No: 26-036

DAUPHIN COUNTY SUBDIVISION/LAND DEVELOPMENT REVIEW REPORT

Plat Title: Final Subdivision Lot Add-on Plan for Marlin E & Arlene M Wagner

Project Description: To add .832 acres from Lot 1 to Lot No. 2, and add 1.309 acres from Lot No. 1 to Lot No. 3, clearing up existing encroachments.

ORIGINAL PROPERTY DESCRIPTION

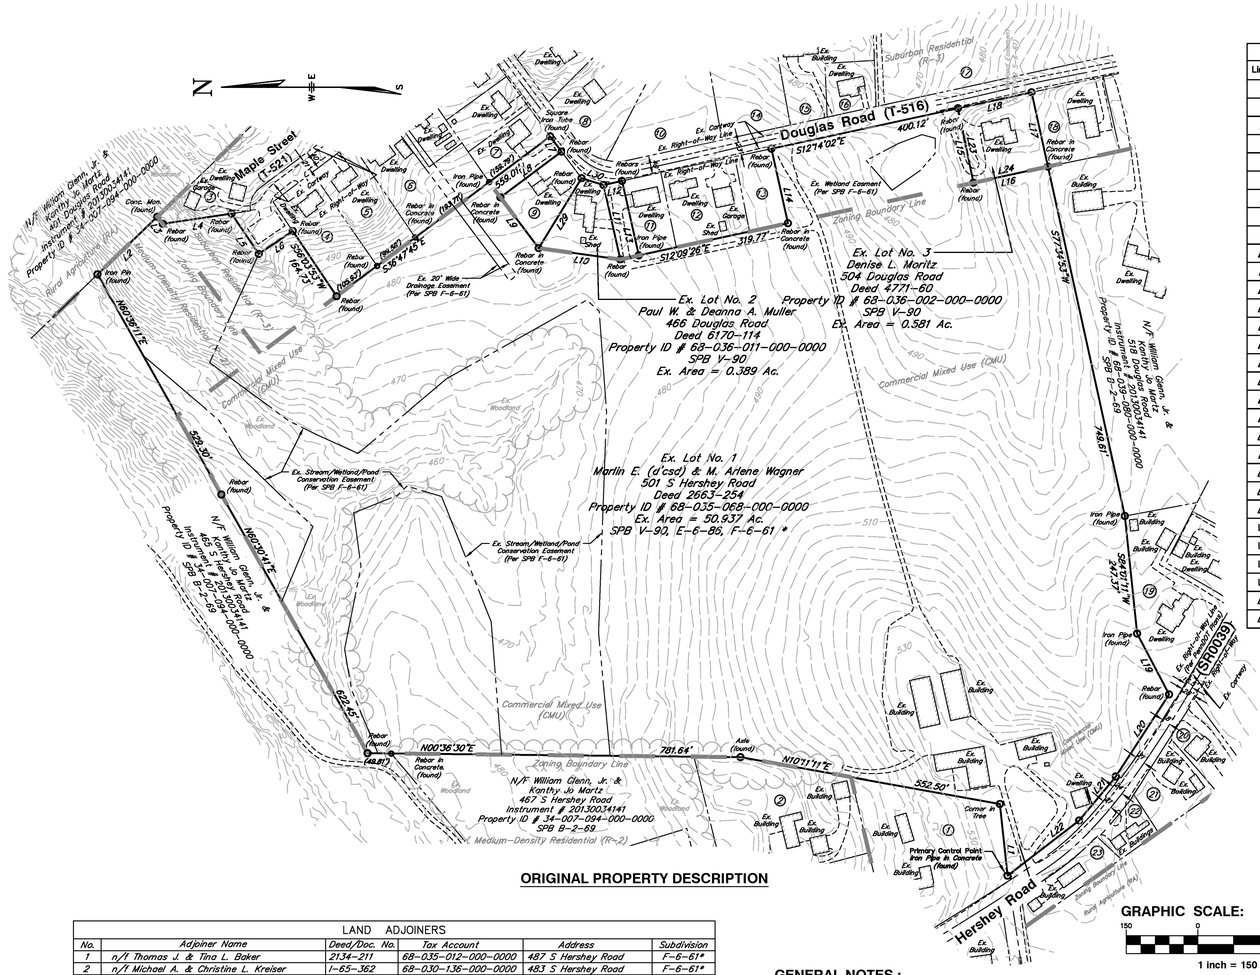
1. The Application for Plan Review to DCPC and the title sheet of the plan indicate this to be a Final Plan, not as a minor subdivision. This plan was reviewed in accordance with the Final Plan requirements in S&LDO § 173.2.08.
2. The Original Property Description map is required to be at a minimum scale of one (1) inch equals four hundred (400) feet. (S&LDO §173.2.08.B.1)
3. All signatures, notarizations, and certifications must be obtained prior to the plan being brought in for signing.
    a. Surveyor/engineer name, seal, and signature (S&LDO §173-2.08-B.16)
    b. Ownership and dedicatory statements with notarization (S&LDO §173-2.08-B.17)
    c. Approval block for the West Hanover Twp Planning Commission should be corrected to read “recommended for approval”. (S&LDO §173-2.08-B.19 and Attachment 4)

Sheet Title:
PROPOSED PROPERTY BOUNDARIES

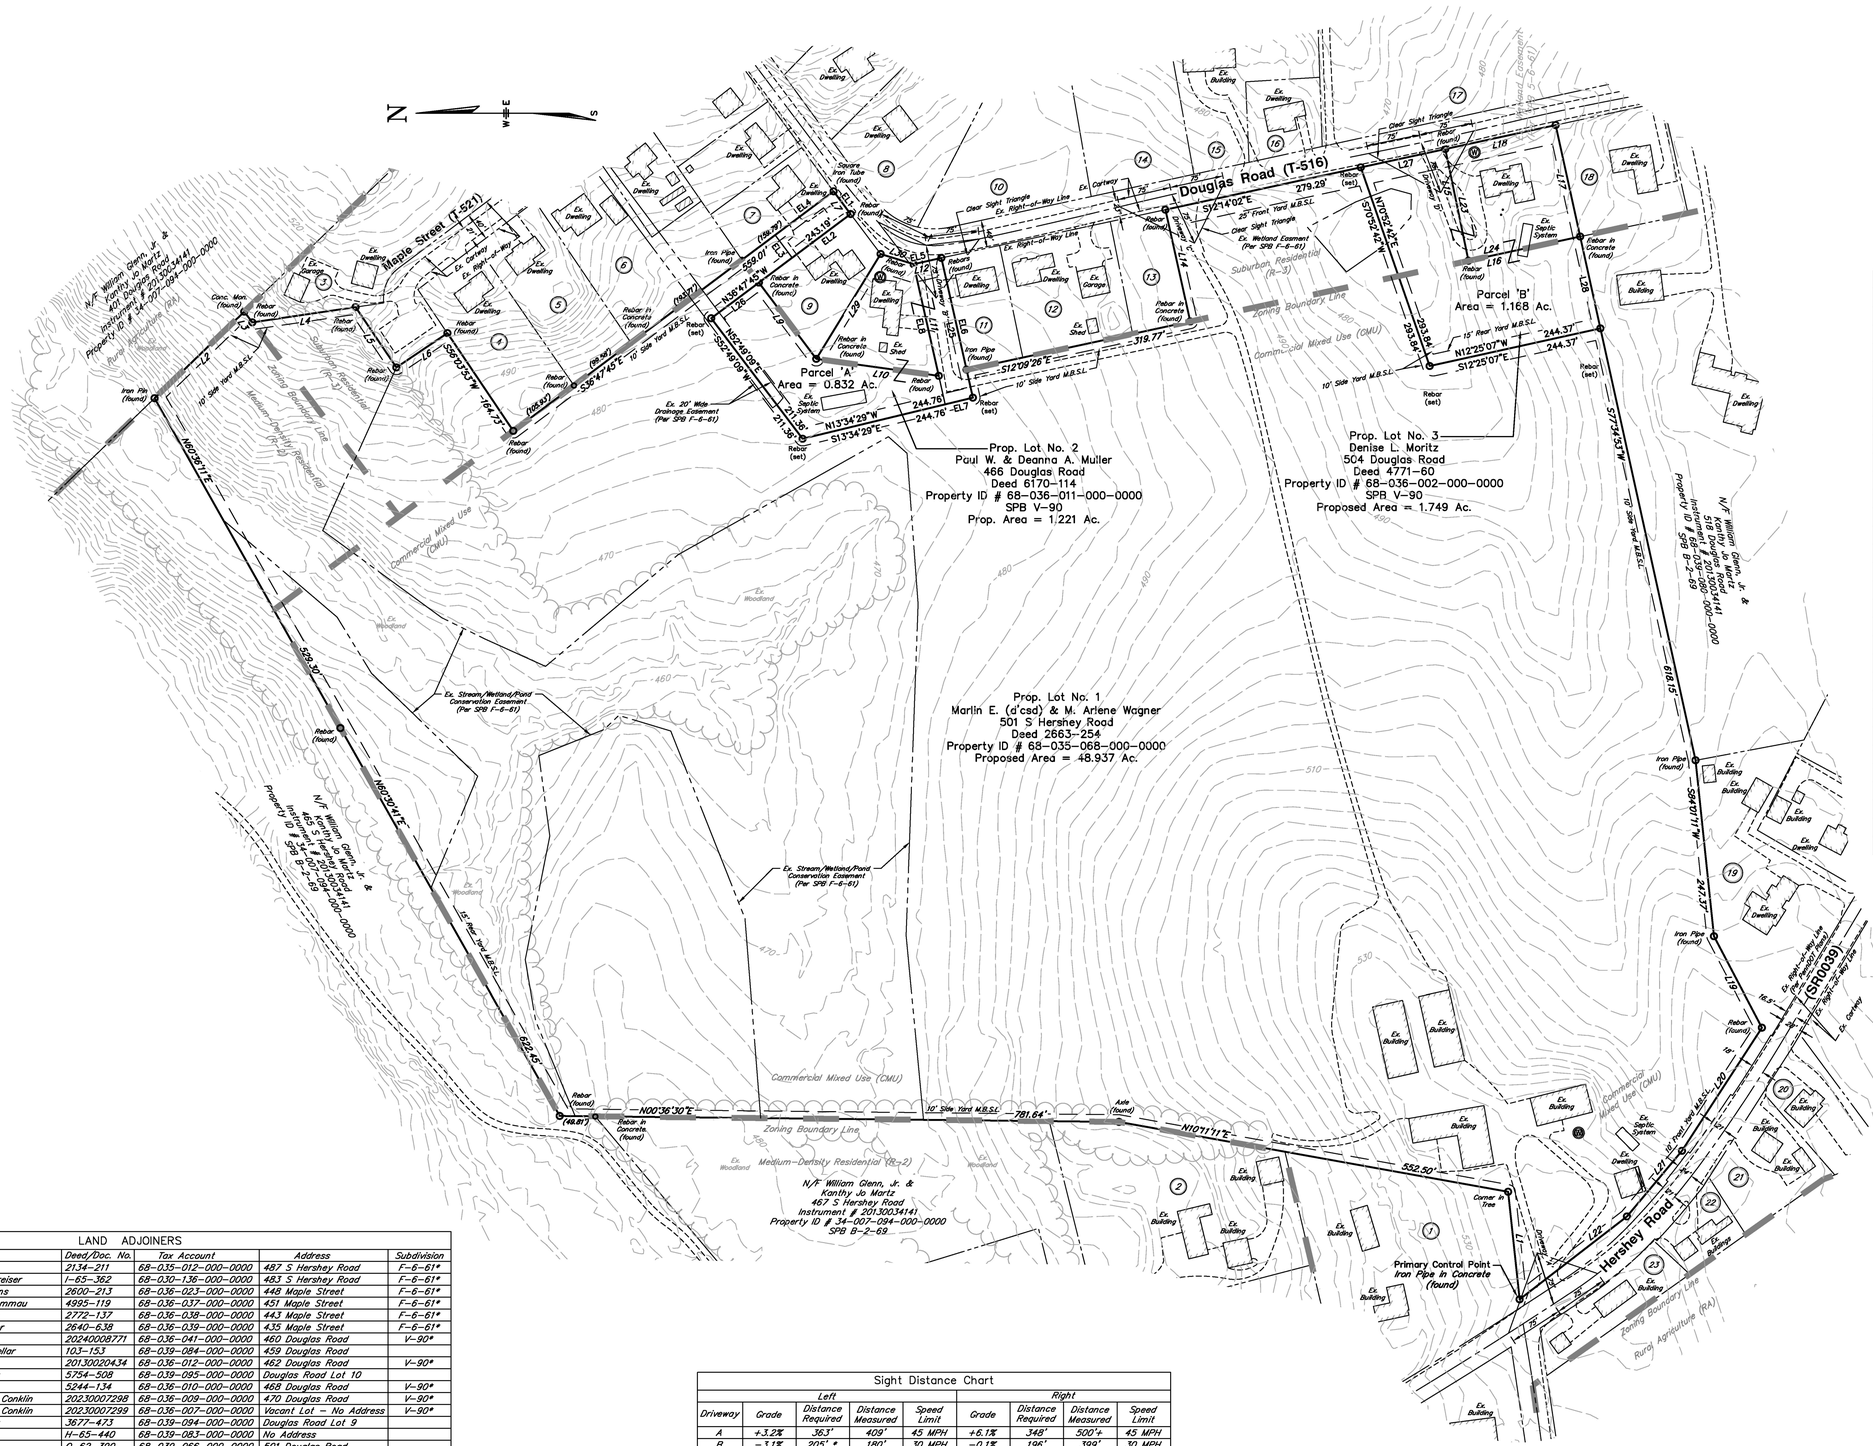
1. Location of existing buildings, streets, septic system(s), stormwater facilities, culverts, fire hydrants, sanitary sewers, well(s), and other significant man-made features located on or adjacent to the proposed lots are required to be displayed. (S&LDO §173-2.08-B.20) Aerial imagery displays a cell/radio tower on existing Lot 1; this is required to be displayed on the map, along with dimensions and easements to access the site. Additionally, aerial imagery indicates an additional building located on Existing Lot 1, which is located within the wooded area behind Existing Lot 2, which is required to be displayed.

4. Existing natural features such as alluvial soils, floodplain, rock outcrops, steep slopes, wooded areas, watercourses, and wetlands delineated in accordance with §3.09 of Chapter 173 are required to be displayed. (S&LDO §173-2.08-B.21) GIS data indicates two areas of wetlands as defined by the National Wetlands Inventory, on existing Lot 1. One of the areas is located on Parcel B, which will become part of Proposed Lot 3. In addition, Parcel B, the proposed lot addition for Proposed Lot 3, contains steep slopes and is required to be displayed.

5. Existing public or private easements, such as but not limited to utility, streams, lakes and ponds, stormwater, erosion control, access to conservation, and location of any public utilities, are required to be displayed. (S&LDO §2.08-B.23) The existing dwellings on Lots 2 and 3, as well as the driveway serving Dwelling 11, appear to require access across Existing Lot 1; therefore, any associated access easements should be shown. Existing Lots 3 and 2 dwellings, and the existing dwelling 11's driveway appear to require access through Existing Lot 1. Additionally, all existing utilities, streams, and other waterways easements are required to be displayed, and in compliance with S&LDO §3.15. All easements should be fully delineated and displayed with dimensions.

1. The plan depicts Driveways B,C, and D as being located within Existing Lot 1; however, a review of the Dauphin County parcel viewer suggests that these areas may not be part of the lot and instead appear to function as roadway segments. The Township Zoning Officer should verify the ownership of these areas.
2. Proposed Lot 1 appears to be still accessible through Driveway B located on Proposed Lot 2. If this access will still be continued, an easement will need to be displayed, along with dimensions.
3. The owner of Dwelling 11, Edward R. Walborn's signature, should be added to the plan, given that access to his dwelling will be affected by this plan.
4. The streams, wetlands, and watercourses are required to be shown on the plan. The plan only displays the conservation easements.
5. A maintenance agreement for the users of Driveway B should be provided to the Township.
